## URBON AT NONA

<p><b>Owner</b> Moss Park Properties</p> <p><b>Applicant</b> Pablo Lopez, Brookstone Nona</p> <p><b>Project Planner</b> Michaëlle Petion, AICP</p> <p><b>Updated:</b> June 10, 2019</p>	<p><b>Property Location:</b> 12501 Wewahootee Rd. (southeast corner of SR 417 and Dowden Rd.) (±48.78 acres, District 1)</p> <p><b>Applicant's Request:</b> The applicant is requesting Master Plan approval for a Specific Parcel Master Plan (SPMP) for 360 unit multifamily development on parcels C &amp; D of the Wewahootee PD. Building types include 2, 3 &amp; 4-stories in height. A 15% height modification is requested in the Office-Low Future Land Use designation to allow a building height of 40 ft. where 35 ft. is the maximum permitted.</p>	<p><b>Staff's Recommendation:</b> Approval of the request, subject to the conditions in this report.</p> <p><b>Public Comment</b> Courtesy notices were mailed to property owners within 300 ft. of the subject property during the week of June 3, 2019. As of the published date of this report, staff has received no comments from the public concerning this request.</p>

Staff recommends approval of MPL2019-10024 subject to the conditions below:

# Proposed Plan

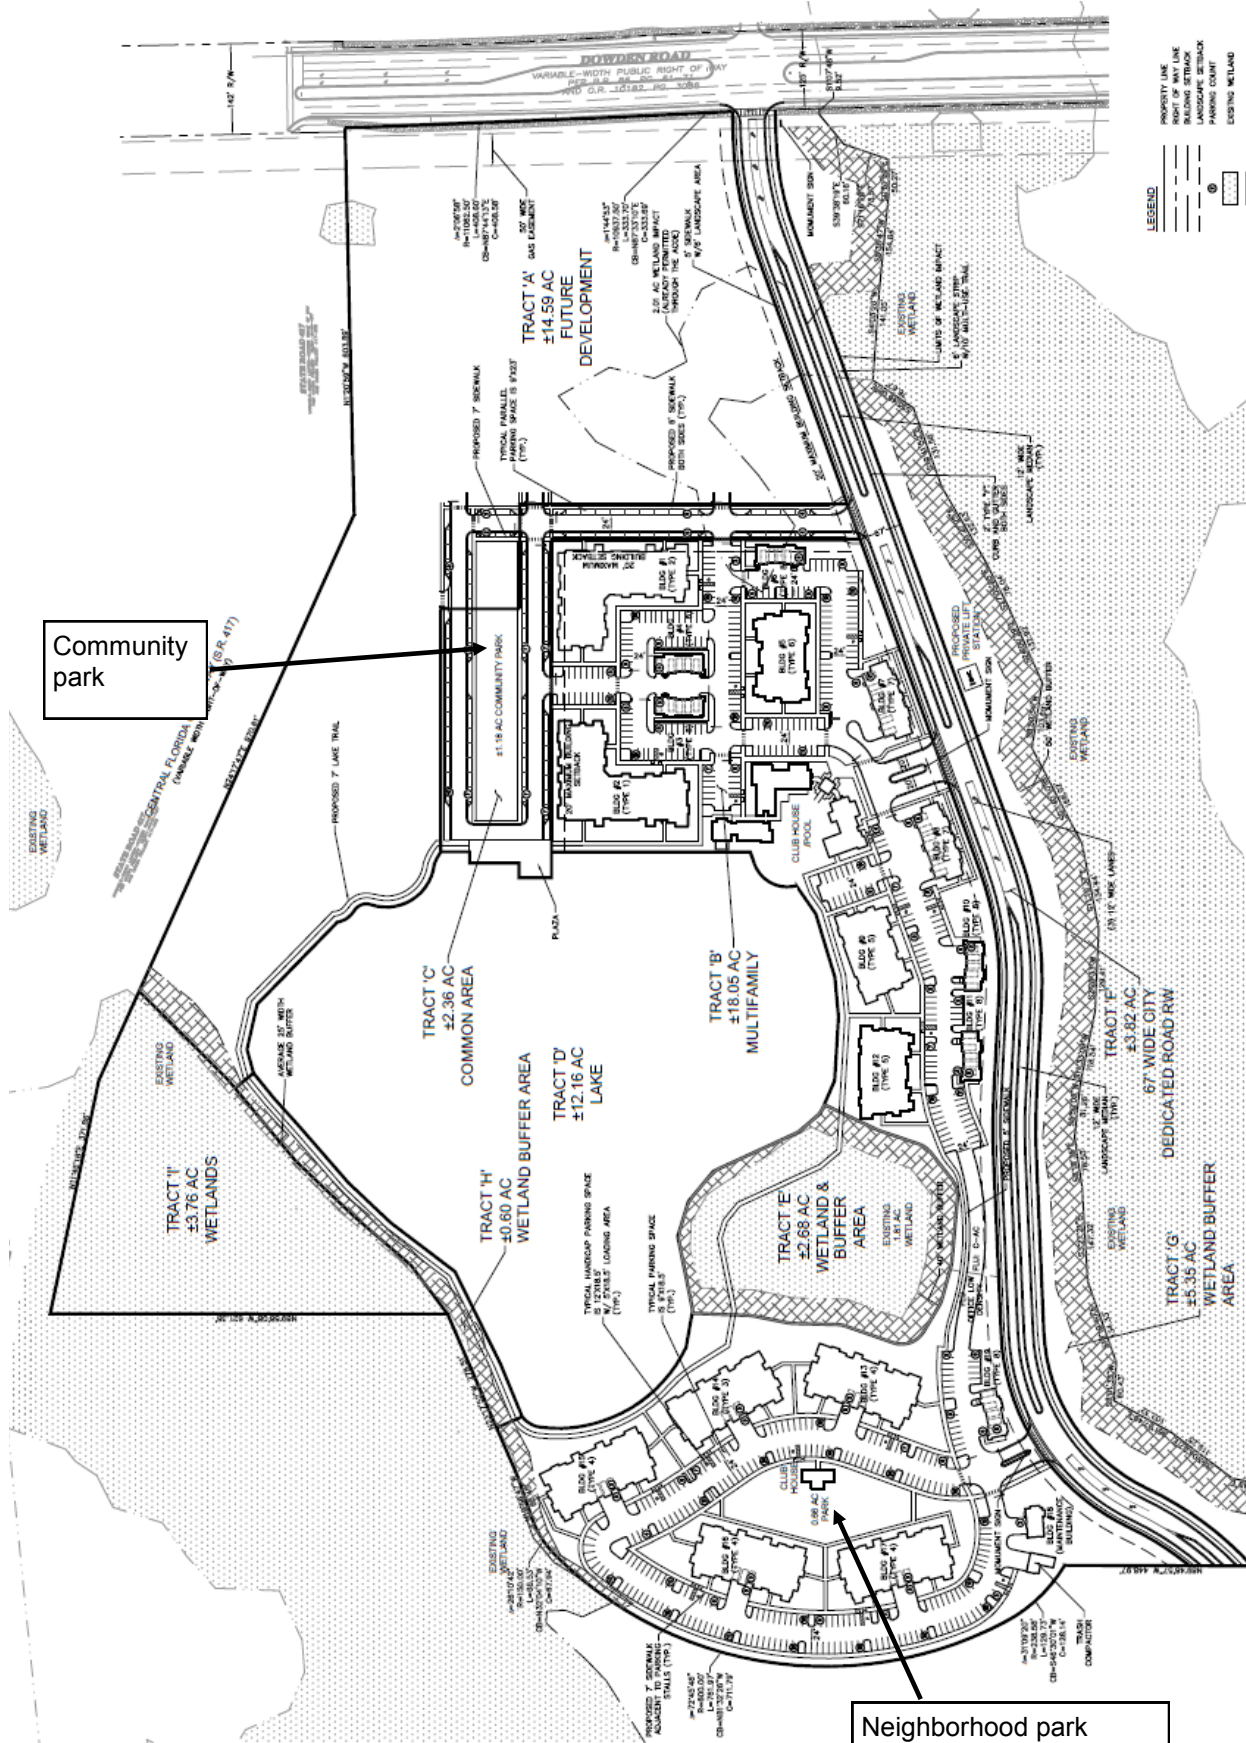
7. Compliance. Plans must be modified to show compliance with the conditions in this report/letter when submitting for building permits.
8. Wetland Setback. Per the PD the minimum building setback from the 25 ft. wetland buffer must be 20 ft., for a total minimum building setback of 45 ft. from the wetland line. Provide proposed setback for 'building #12' to ensure compliance.

9. Phasing. If developed in multiple phases, each phase must function independently of each other and meet all requirements independently.
10. Primary Street. The street with the parallel parking spaces along the northern and western perimeter of the multifamily site will be considered the primary street for PD purposes. It is to be designed with parallel parking and 6 ft. wide sidewalks. Also, the 90 degree parking stalls (adjacent to the primary street) may not project in front of the building facades (applicable to buildings #1, 2 & 6).

- a. A complete pedestrian connection must be provided around Track D (Lake). Provide a connection from building 2 to building 9. The applicant shall coordinate with staff on the pedestrian connection from building 2 to building 9 to provide a seamless connection between the two.

- b. At the main street locations, To help keep the speed of traffic down and to provide a greater tree canopy, provide bulb-outs every 4 parking spaces. Bulb-out to include a canopy tree

- c. Sidewalk connections to the main pedestrian circulation are needed at building 3,4,6, 5, 10,11,19, & 18
- d. Knee walls, a maximum of 3 ft. tall, must be provided at all parking stalls facing the ROW to be dedicated to the City (Tract 'F'). This is to occur adjacent to building 19,11,10,8 & 7. Knee walls are to have identical materials to match building on site.

- f. Tandem parking spaces shall not encroach in to the pedestrian sidewalks. Parking stalls in front of garages shall have a minimum parking length of 18.5 ft.

- i. Additional sidewalks maybe required at time of permitting review to complete the pedestrian circulation.
- j. Remove the sidewalk at the southern most parking area.

- k. Add sidewalks on both sides of the road at the southern entrance of the site.
- l. Add an additional sidewalk from building 17 to eastern parking stall area sidewalk.

- m. Provide A minimum of 7.5ft landscape strip adjacent to the main drive aisle east of the wetland.

Elevations

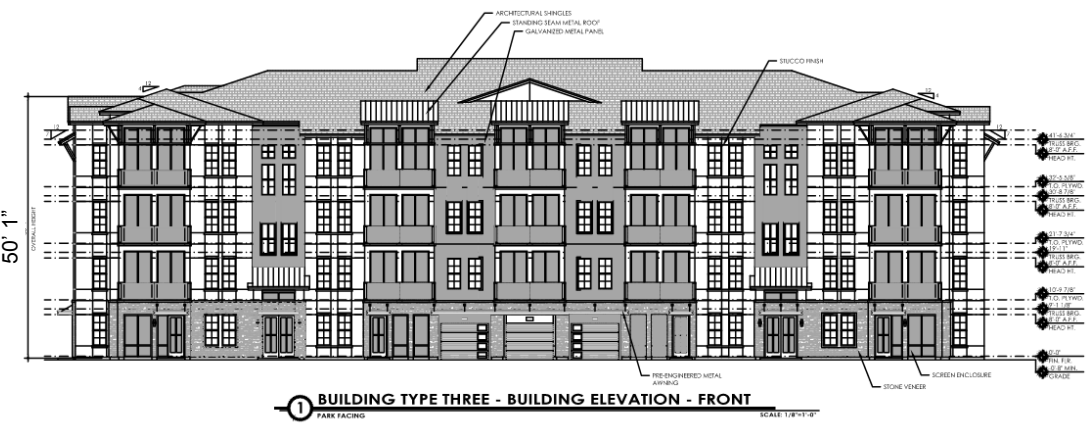
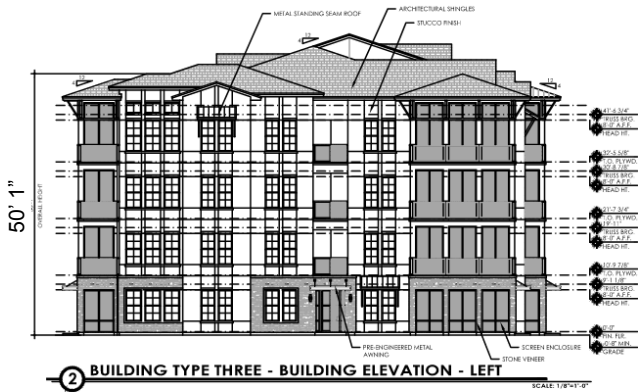
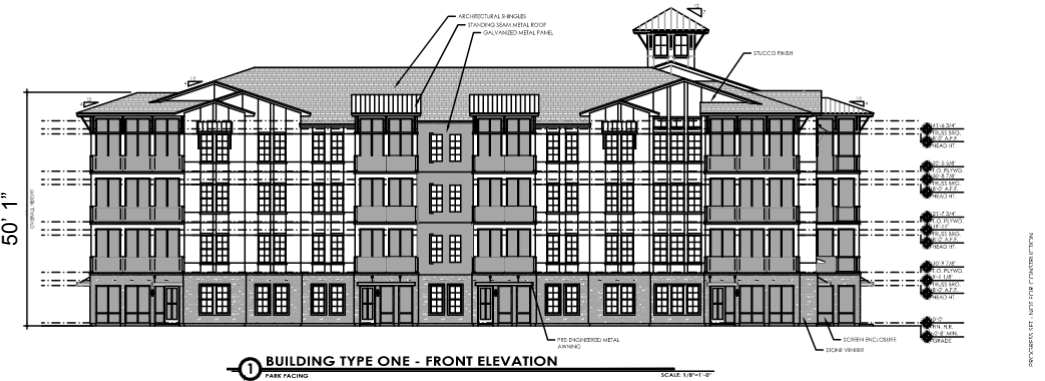
- a. Deviation from the submitted elevations will require necessitate additional review requirements.
